| Model | | NA2 (European & Taiwan versions only) | | | | | Volt/Hz | | Date of Modification | | Serial Number | | | |
| Modified Article | | | | | | | | | | | | | | |
| Reason for Modification | | To prevent thin white lines | | | | | | | | | | | | |

DETAILS OF MODIFICATION

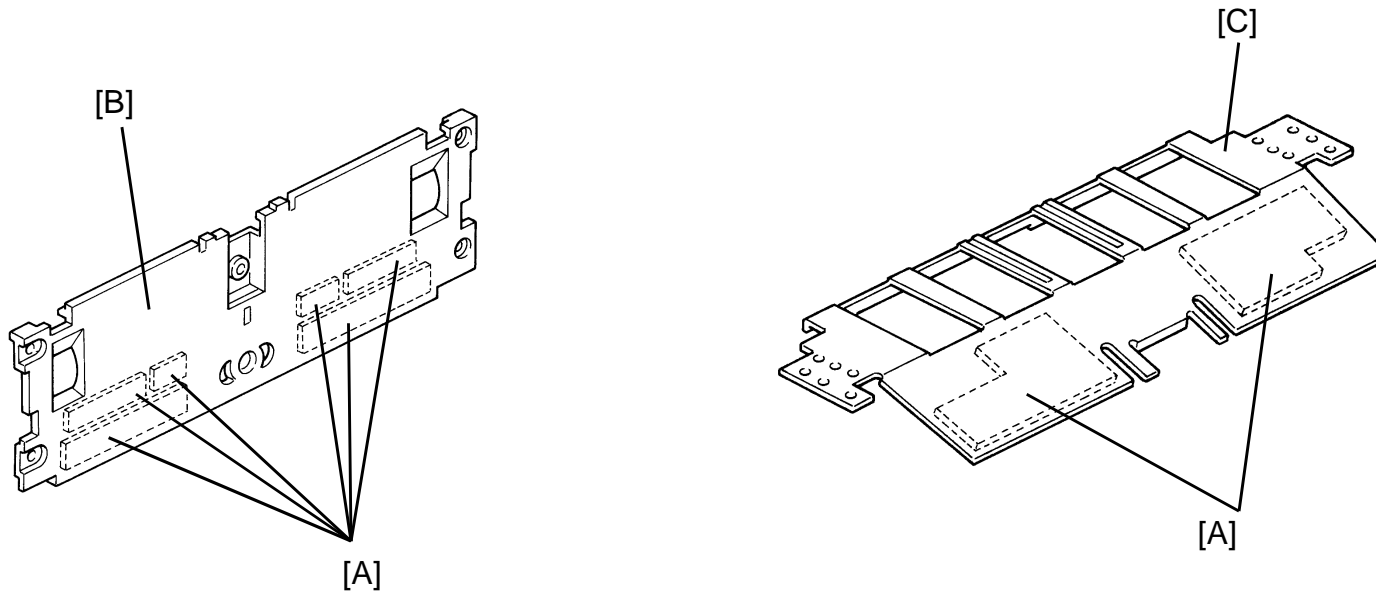
To reduce paper feed noise, vibration absorbing pads [A] have been added to the Paper Entrance Plate [B] and the Lower Paper Guide Plate [C].

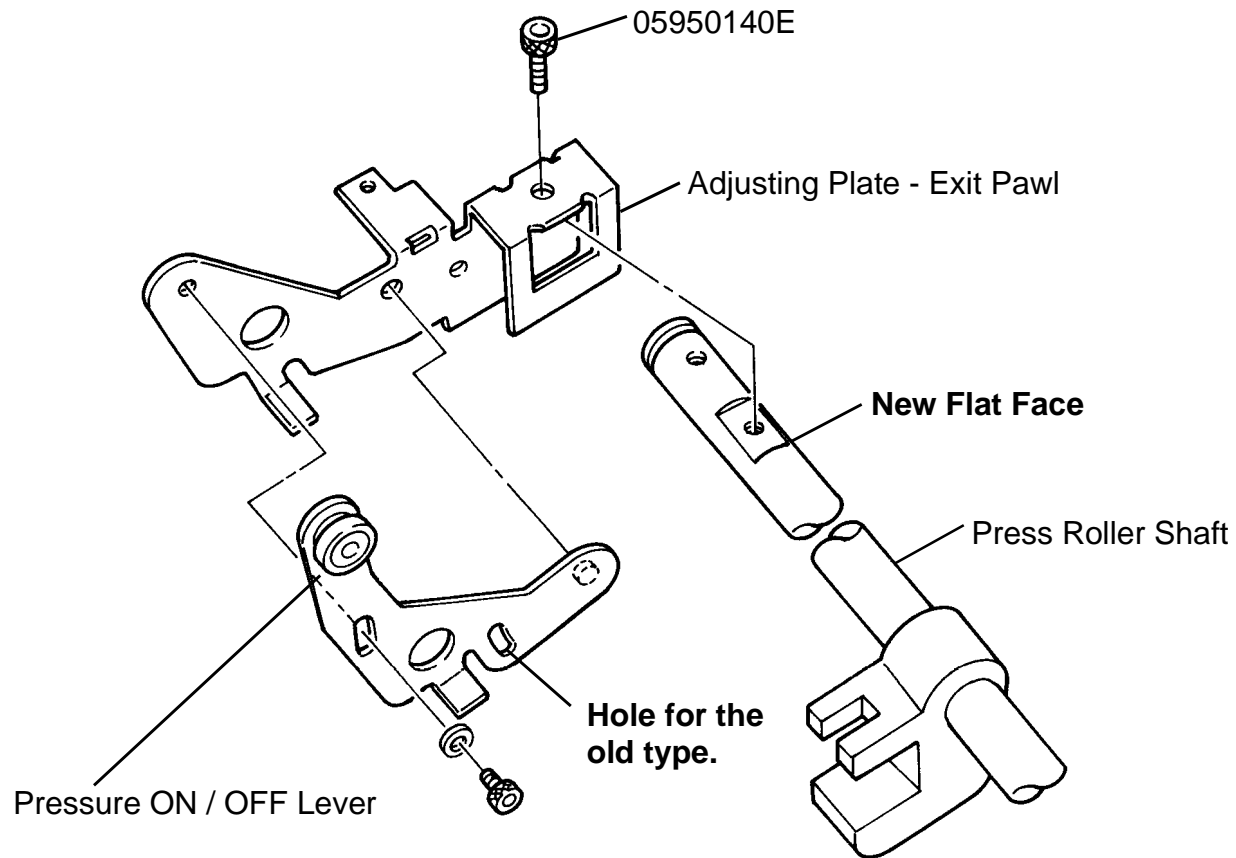
A flat face has been added on the shaft as shown on the next page.

Due to the added flat face on the shaft, the connecting part has been lowered 2 mm.

To ensure that this part is fixed to the adjusting plate in the exact correct position and that it does not move during operation, the distance between the two screw holes has been increased. (The position of the screw holes on the adjusting plate side has also changed.) This part can be installed with the old type adjusting plate because it has a screw hole for the old adjusting plate (C2095570). This part is needed only when the optional A4 drum is used.

Page 19 DRIVE SECTION II

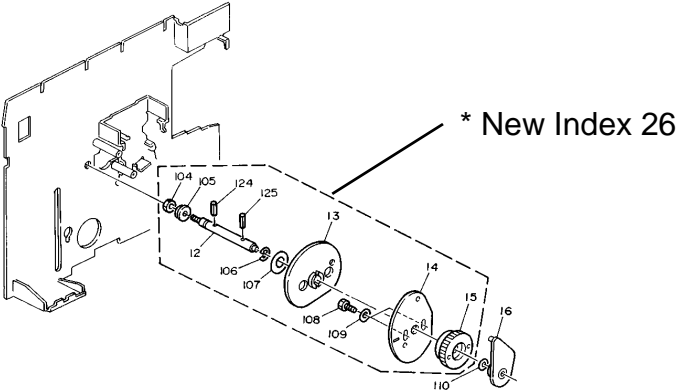
Add the following part and correct the illustration as shown below:

| New Index | P/N | Incorrect Description | Q'ty |
|-----------|----------|-----------------------|------|
| 26 | C2095101 | Feed Cam Ass'y | 1 |

Page 45 PAPER EXIT SECTION III

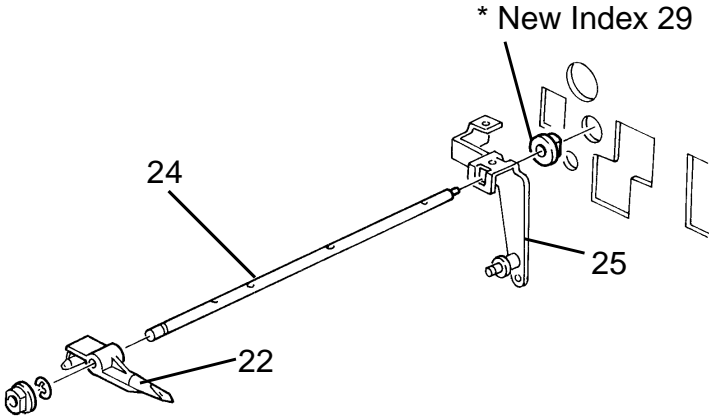
Add the following part and correct the illustration as shown below:

| New Index | P/N | Incorrect Description | Q'ty |
|-----------|----------|-----------------------|------|
| 29 | C2032083 | Exit Pawl Bushing | 1 |

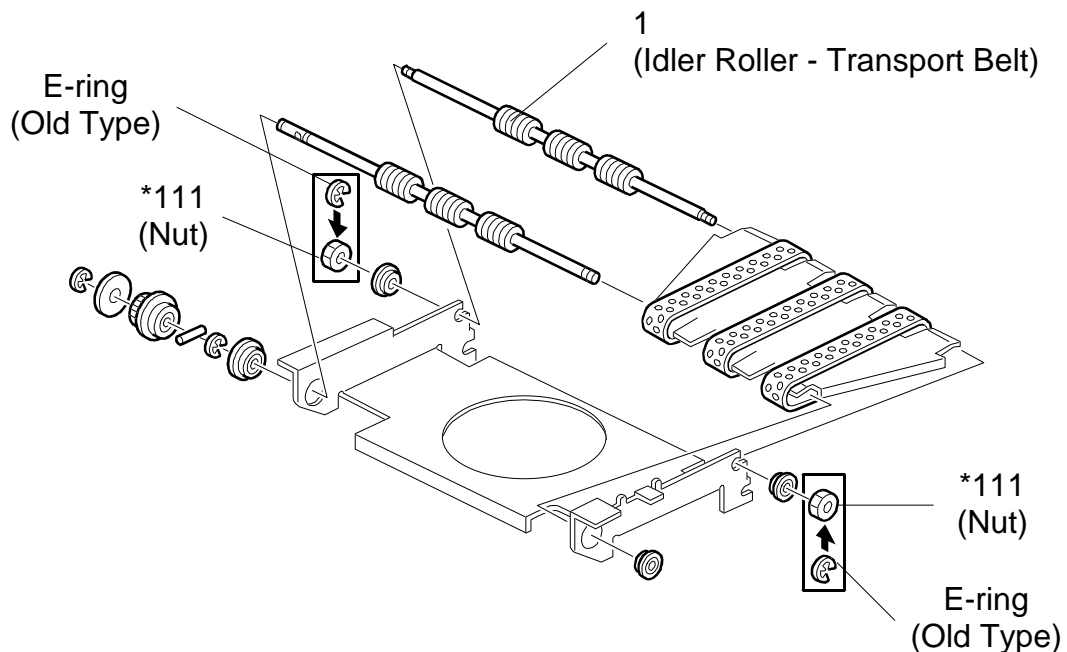
Due to part standardization, the idler roller used in the paper delivery vacuum unit (Idler Roller - Transport Belt) has been modified. Both ends of the roller shaft have been threaded to fit with nuts instead of E-rings (Retaining Ring - M4), as shown below.
